PIC24FJ64GA004 Family Silicon Errata and Data Sheet Clarification

The PIC24FJ64GA004 family devices that you have received conform functionally to the current Device Data Sheet (DS39881D), except for the anomalies described in this document.

The following typographic corrections and clarifications are to be noted for the latest version of the device data sheet (DS39881D):

FIGURE 2-3 FREQUENCY vs. ESR PERFORMANCE FOR SUGGESTED VCAP

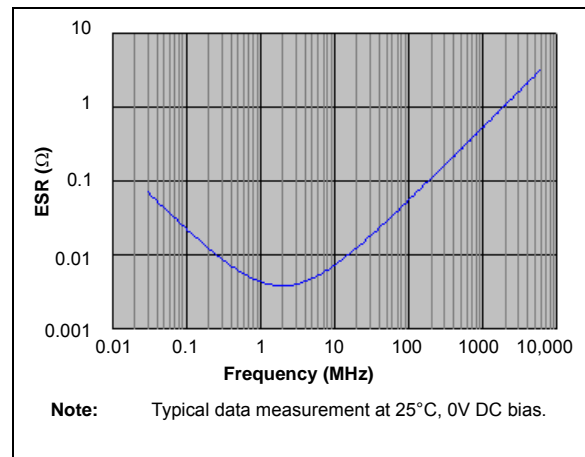
Designers may use [Figure 2-3](#) to evaluate ESR equivalence of candidate devices.

When the regulator is disabled, the VCAP/VDDCORE pin must be tied to a voltage supply at the VDDCORE level. Refer to **Section 27.0 “Electrical Characteristics”** for information on VDD and VDDCORE.

FIGURE 2-4 DC BIAS VOLTAGE vs. CAPACITANCE CHARACTERISTICS

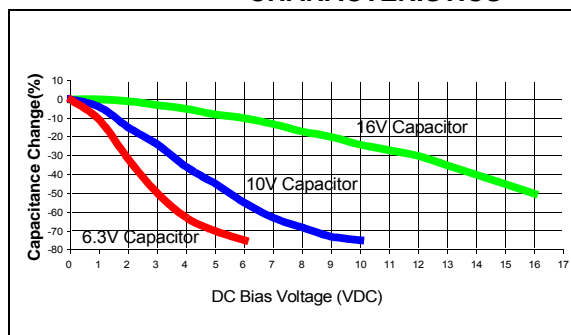
In addition to temperature tolerance, the effective capacitance of large value ceramic capacitors can vary substantially, based on the amount of DC voltage applied to the capacitor. This effect can be very significant, but is often overlooked or is not always documented.

A typical DC bias voltage vs. capacitance graph for 16V, 10V and 6.3V rated capacitors is shown in Figure 2-4.

When selecting a ceramic capacitor to be used with the internal voltage regulator, it is suggested to select a high-voltage rating, so that the operating voltage is a small percentage of the maximum rated capacitor voltage. For example, choose a ceramic capacitor rated at 16V for the 2.5V core voltage. Suggested capacitors are shown in Table 2-1.
